Experimental Study on Stability and Wave Force of Breakwater Junction under Multi angle Oblique Waves

Guang-sheng WANG, Long-zai GE *, Tong YU, Ya-jing ZHANG *, Song-gui CHEN

Figure 4. Layout plan of the breakwater transition on the model.

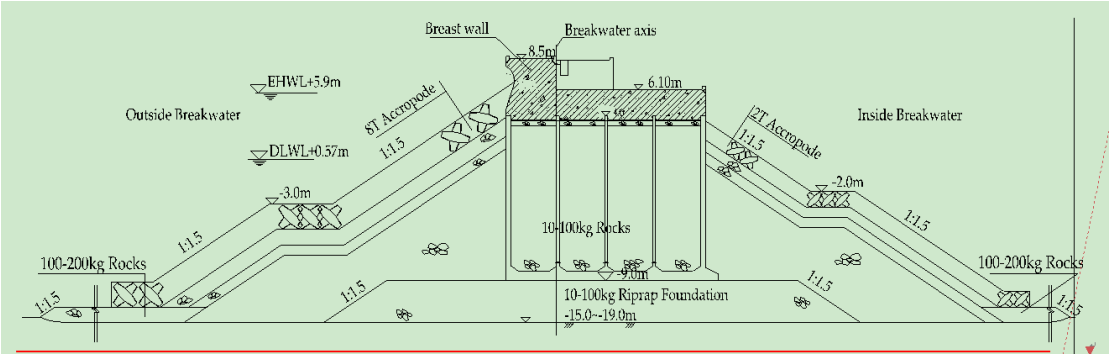
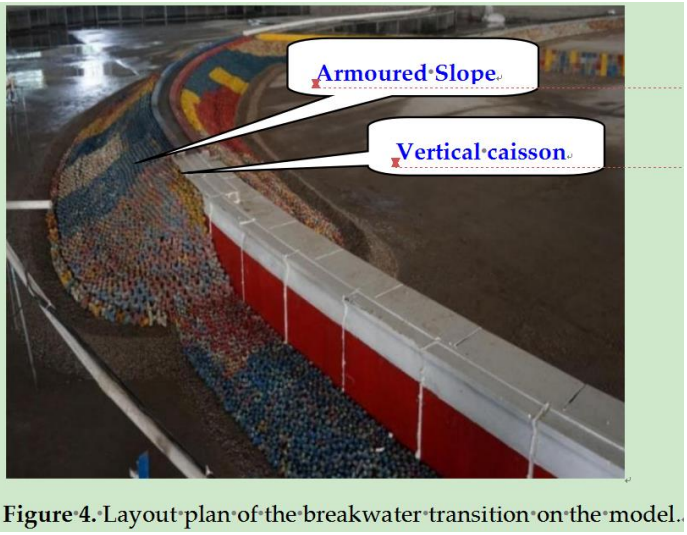
（5）Figure 3, Figure 4, etc.: It would be good to use the same font as for the rest of the manuscript (Palatino Linotype)

Reply: Thank you for your comments. It has been supplemented as follows:

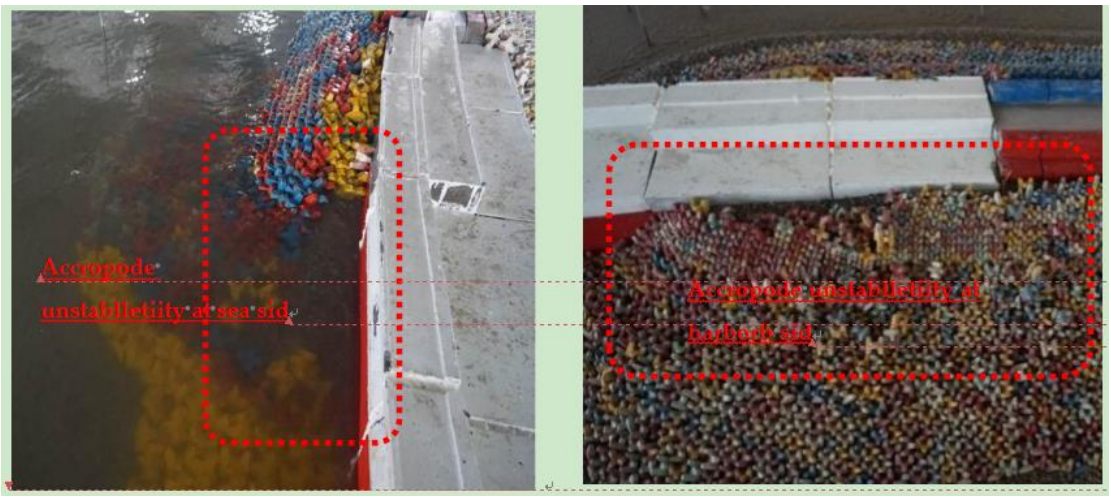
（6）L301: Add the percentage of difference between Van der Meer and Chinese standards.

Reply: Thank you for your comments. Has been supplemented. The details are as follows:

The difference between Chinese standards and Van der Meer is ±20%.
